ASSESSMENT REPORT

Section 96(1A) Modification Kings Park Metal Recovery (SSD 5041 MOD 1)

Figure 2: Proposed Modifications to Approved Site Plan

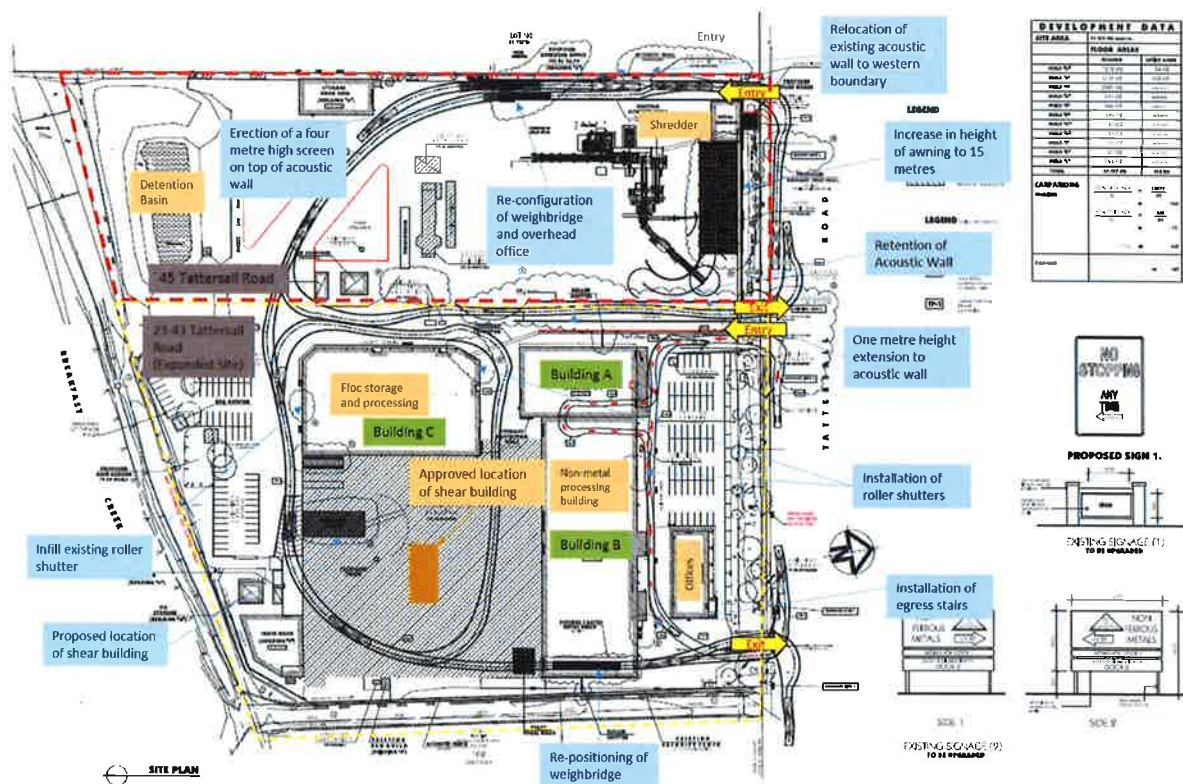
The modification application does not seek to amend the processing activities on site or increase the processing capacity of the facility. Rather, the modification seeks approval for minor changes to the layout and built form of the facility. The Applicant suggests the modification is required to increase operational efficiencies and better utilise the site area. The modification application proposes the following:

- relocation of an existing acoustic wall to the western boundary of the site to permit the widening of the internal road to facilitate two-way movement of trucks;

- erection of a four metre screen on top of the relocated acoustic wall;
- a one metre height extension to the acoustic wall which separates the existing processing area from the entry driveway;

- re-configuration of entry weighbridges and overhead weighbridge office;
- retention of acoustic wall between 23-43 Tattersall Road and 45 Tattersall Road;

- installation of roller shutters in the processing buildings at 23-45 Tattersall Road;
- increase in height of the proposed non-ferrous processing three sided enclosure from 10 metres to 15 metres;

- repositioning of the proposed shear building approximately 18 metres to the south-west; and
- relocation of existing exit weighbridge to within Building B; and

Figure 2: Proposed Elevation of Development from Tattersall Road

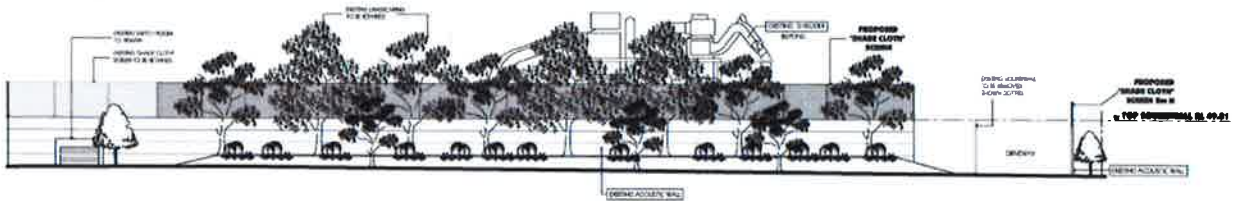
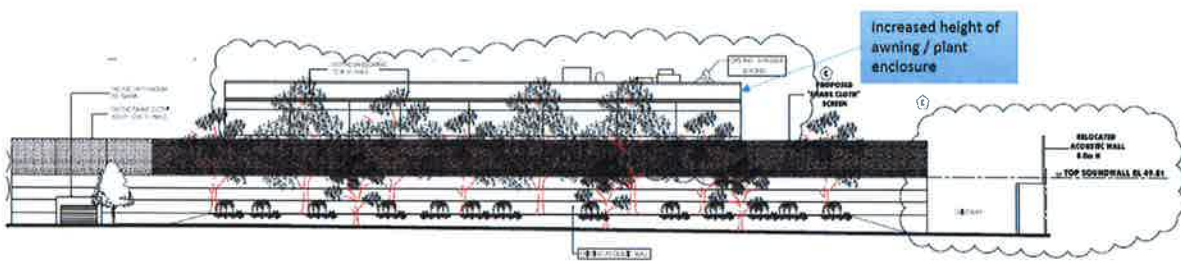
The awning is located immediately adjacent to Tattersall Road (see **Figure 2 and 3**). At 10 metres in height, the awning does not visually or acoustically screen the recycling plant from Tattersall Road. The Applicant argues that at a height of 15 m the awning screens the majority of the recycling plant from view from Tattersall Road and therefore the increase in height is beneficial (see **Figure 3**). Further, the Applicant suggests the existing and proposed landscaping treatments effectively screen the awning when viewed from Tattersall Road.

In its submission, Council raised concerns regarding the amended height of the proposed awning (from 10 m to 15 m in height). Council suggested the location of the awning at the boundary of Tattersall Road will have an imposing effect on the streetscape. Council also requested that the details of the external finishes and treatments of the awning be provided to ensure methods to assist in breaking up bulk and scale of the structure are utilised.

In a report responding to the submissions, the Applicant addressed Council's concerns by stating the external finish of the awning will encompass prefabricated "heritage green" steel panels. The Applicant also suggested the view of the awning structure from Tattersall Road will be screened by existing mature trees and acoustic wall.

Council reviewed the Applicant's submission report and suggested additional trees be planted at the street frontage and the existing shade cloth atop the acoustic wall be replaced. The Applicant, in response, provided revised plans to indicate the shade cloths will be replaced and additional plantings will be provided.

The Applicant's argument that the landscaping will mask the appearance of the awning from Tattersall Road is problematic as landscaping is not considered a sustainable impediment to unsightly construction. The awning itself will be constructed of painted prefabricated steel and is to be located immediately adjacent to the road frontage. The appearance of the structure from the street would be imposing. However, its ultimate purpose of masking the unsightly appearance of the existing 16 m high metal recycling plant would prove beneficial to the appearance of the development when viewed from the street. The existing landscaping would aid in masking the appearance of the awning and
